Staff Report

Re: **Pier 70 Waterfront Site Special Use District Parks**

Project Review

**PIER 70
SHORELINE
OPEN SPACE**

**PIER 70
WATERFRONT OPEN SPACES
ILLUSTRATIVE SITE PLAN**

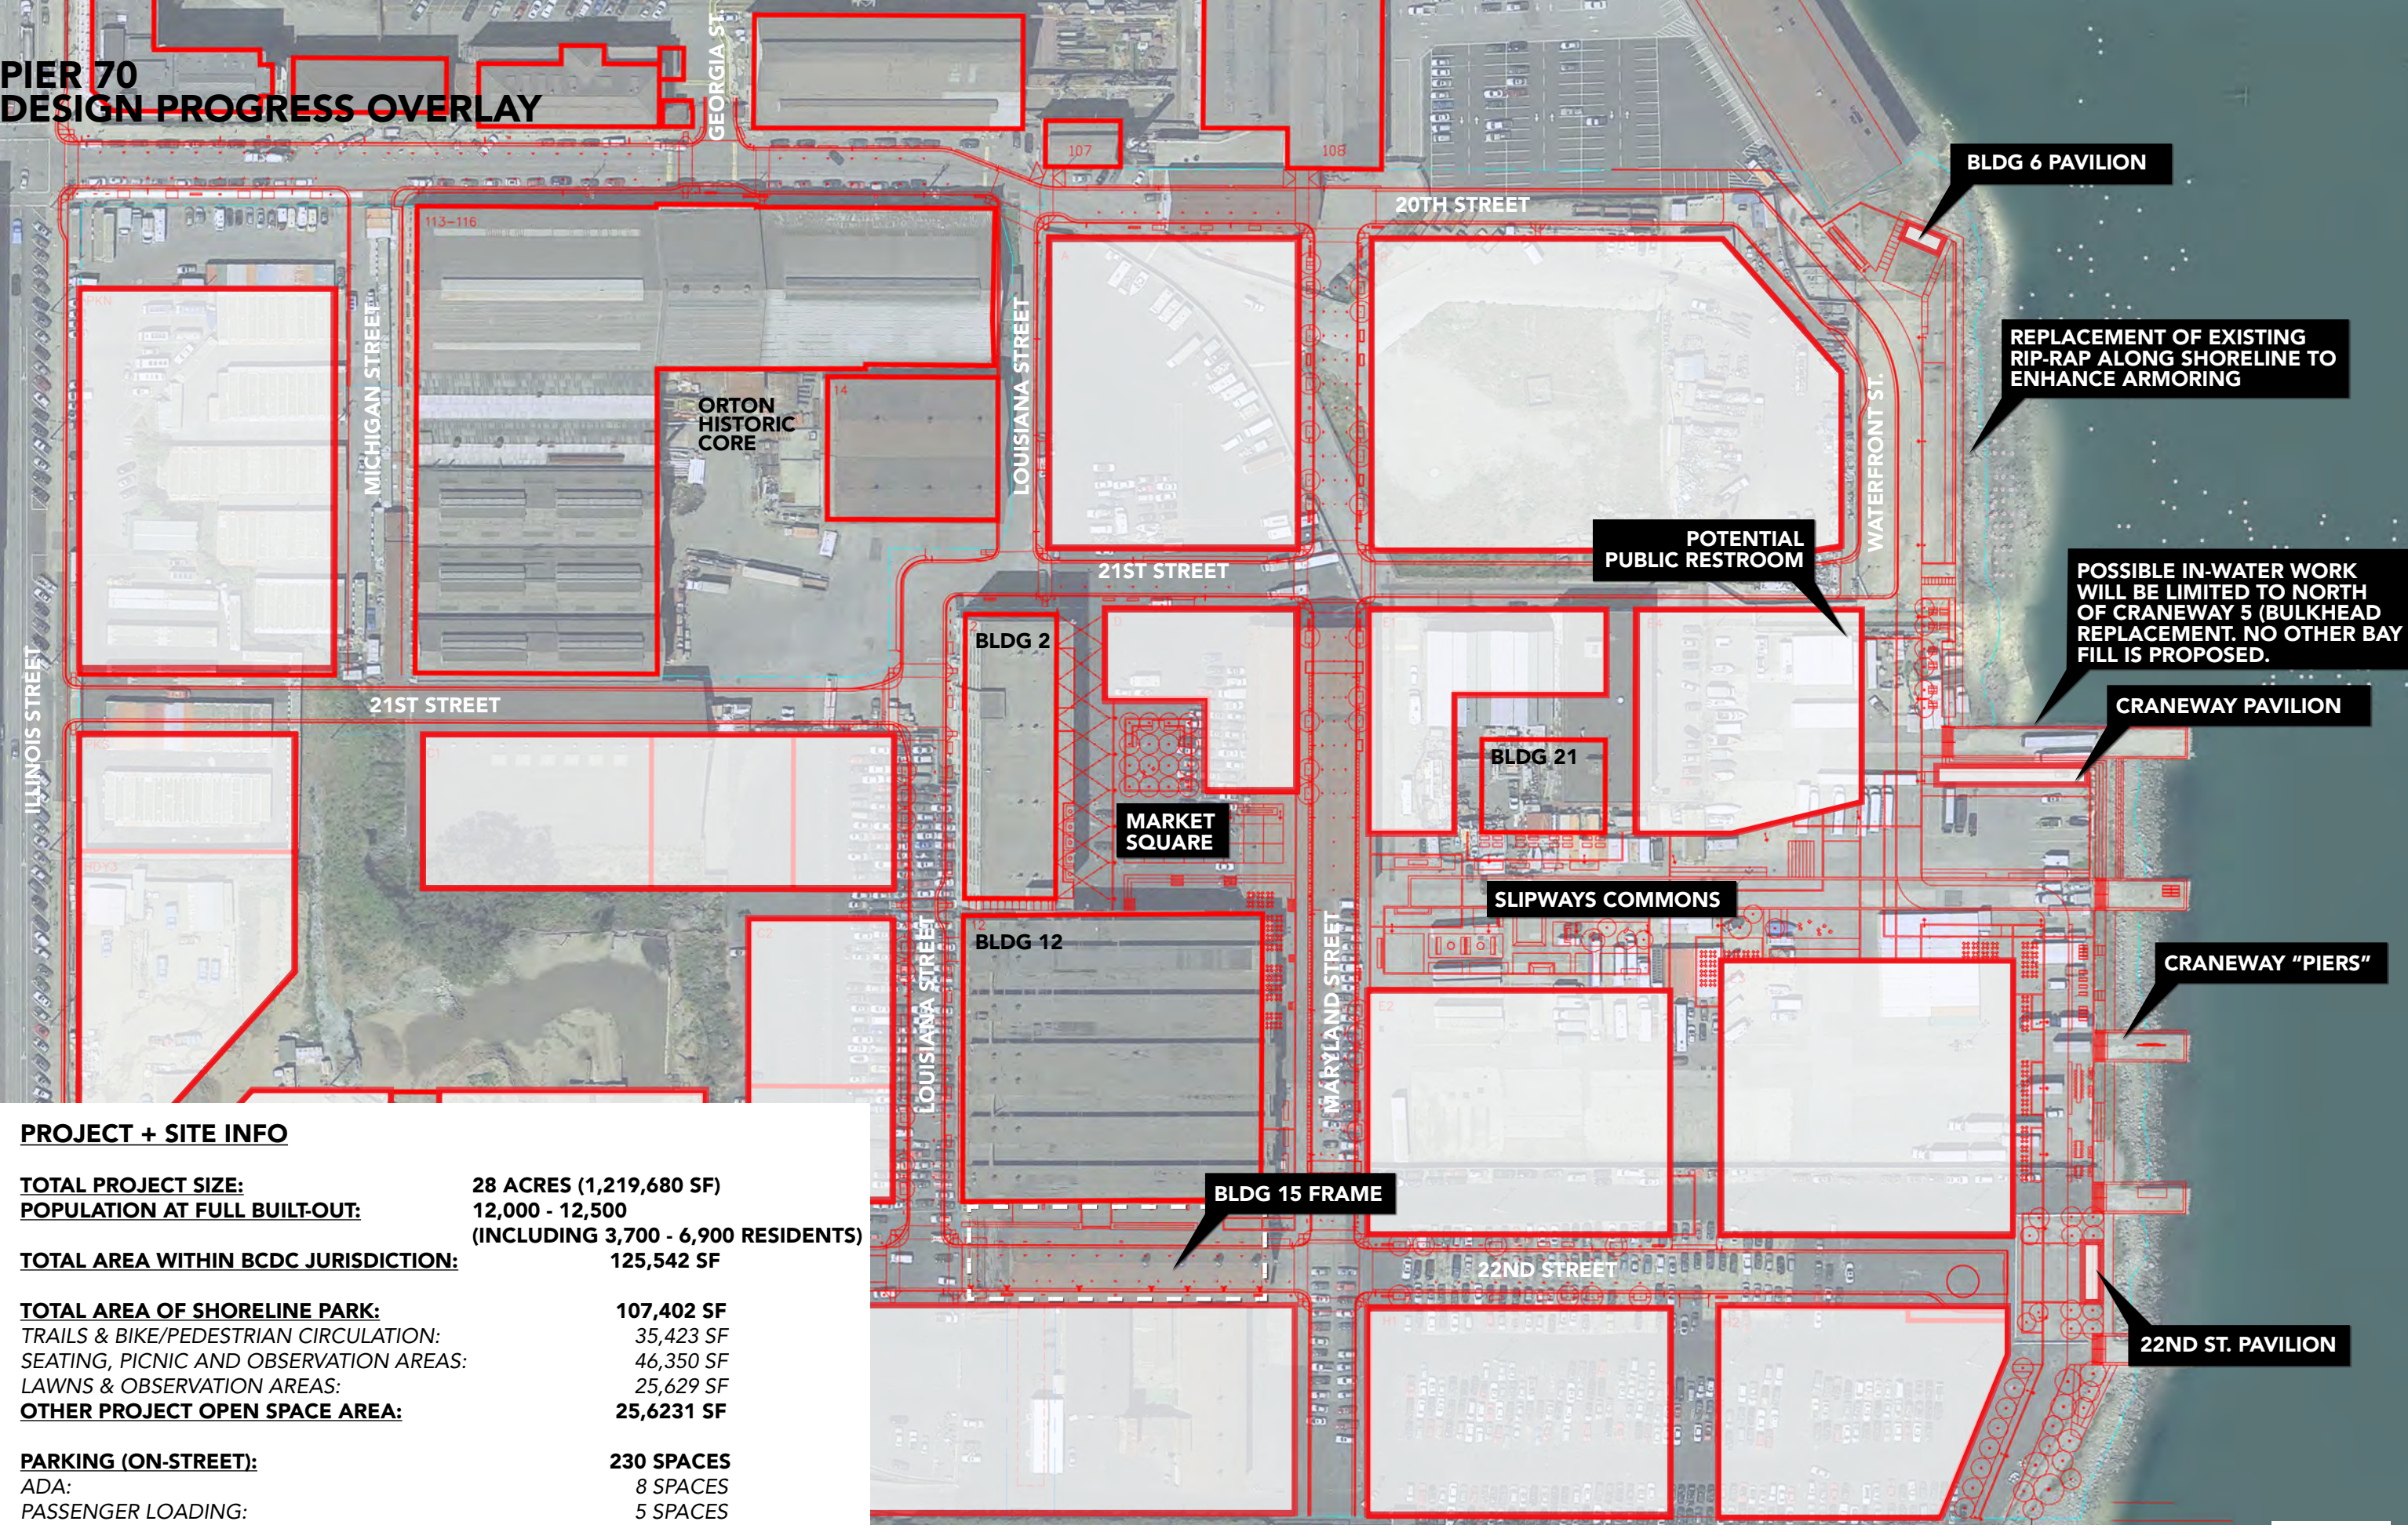
Page #	D4D Guideline	Staff Comment
2	S3.3.2	Site Lines - Tree plantings within Slipways Commons adjacent to buildings E2 & E3 block views of historic building 12 from the shoreline and are not consistent with the planting plan described in section 3.13 and figure 3.13.1
2	G3.2.2	Vegetation- The plans illustrate two new locations with shade trees, including at the eastern foot of both 21 st and 22 nd Streets. The 22 nd street view looking east is framed by the street trees. Staff does not believe the addition of more trees is needed or consistent with historic industrial nature of the site. The proposed tree planting is not consistent

<p>with Exhibit 3.13.1 on page 83, which illustrates the approved planting plan concept.</p> <p>Additionally, within the Waterfront Terrace area, new and additional lawn area has been introduced south and adjacent to Building 6 surrounding the viewing pavilion. This additional landscaping is not consistent with the planting plan in the D4D and staff has concerns that the plan is not consistent with the National Register district character defining feature of “minimal planted vegetation”.</p>
	Other	<p>Waterfront Terrace - Cobble Beach- The proposed cobble beach is not an acceptable design. The concept of providing access to the Bay in this location raises multiple concerns, including proximity to the ship repair operations, security around and under Building 6, wave and tidal action, and accessibility compliance with ADA. Until there is further understanding of the reuse of Building 6 and the future of the ship repair operations, access to this area must be restricted.</p>
